Process Sheet

Customer : CU-DAR001 Dart Helicopters Services Drawing Name : 206L AFT X-TUBE
Job Number : 41391
Estimate Number : 10973
P.O. Number :
This Issue : 19/08/2008 S.O. No. :
Prsht Rev. : NC Part Number : D206667203 BL
First Issue : / / Type : CROSSTUBES Drawing Number : D206-667-243 REV B + DSI 9415 Rev A
Previous Run : 40117 Drawing Revision : B
Material :
Due Date : 05/09/2008 Qty: 1 Um: Each

DART SERVICE INSTRUCTION

TO AMEND INSTALLATION INSTRUCTIONS IIN-D206-667 REV. C AND
INSTRUCTIONS FOR CONTINUED AIRWORTHINESS ICA-D206-667 REV. 2
REF: CANADIAN STC: SH01-5
REF: FAA STC: SR01304NY

FIGURE 1 - CROSSTUBE SUPPORT

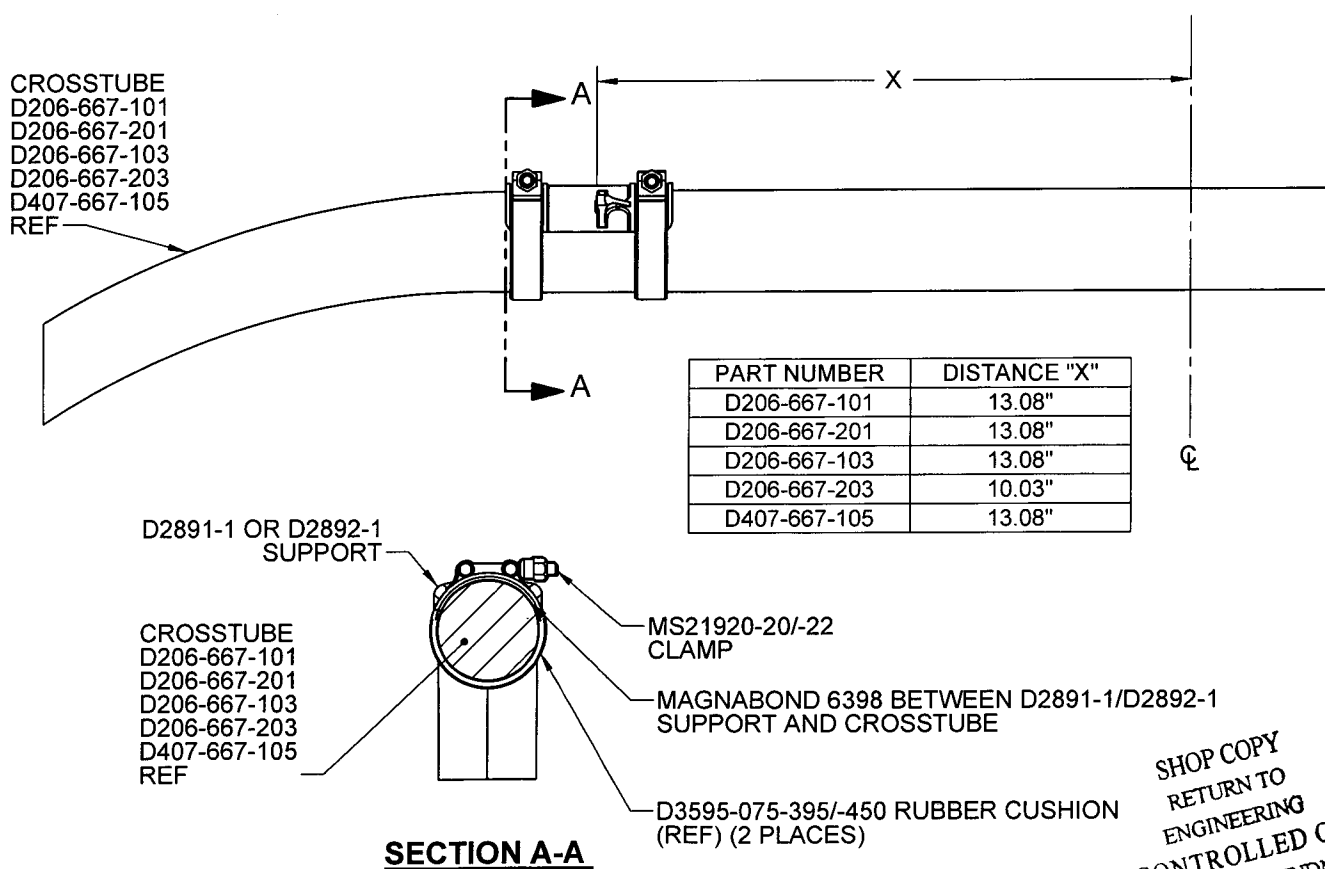
For D206-667-101/-201/-103/-203 or D407-667-105 cross tubes at CHG 003 or later, the D2856-400-694/-773 abrasion strip has been removed, the center D2891-1 or D2892-1 support has been bonded onto the crosstube using Magnabond 6398 and D3595-075-395/-450 Rubber Cushions have been installed underneath the MS21920-20/-22 Clamps. Amend parts list of the IIN-D206-667 section 5 and ICA-D206-667 Section 32.8 as follows:

To prevent the supports from shifting on the D206-667-101/-201/-103/-203 or D407-667-105 crosstubes at CHG 002 or earlier, the D2891-1/D2892-1 supports should be removed and re-installed as follows:

- 6) Apply a 0.03" to 0.06" thick layer of Magnabond 6398 underneath the D2891-1/D2892-1 support and re-install the support on the crosstube as shown in Figure 1. Position and secure the D2891-1/D2892-1 support on the crosstube using MS21920-20/-22 Clamps. Install a D3595-075-395/-450 Rubber cushion underneath each MS21920-20/-22 Clamp. Torque clamps 80-100 in-lb. Let the D206-667-101/-201/-103/-203 or D412-667-105 crosstube assembly cure as per the Magnabond 6398 instructions before re-installing the crosstube on the aircraft.
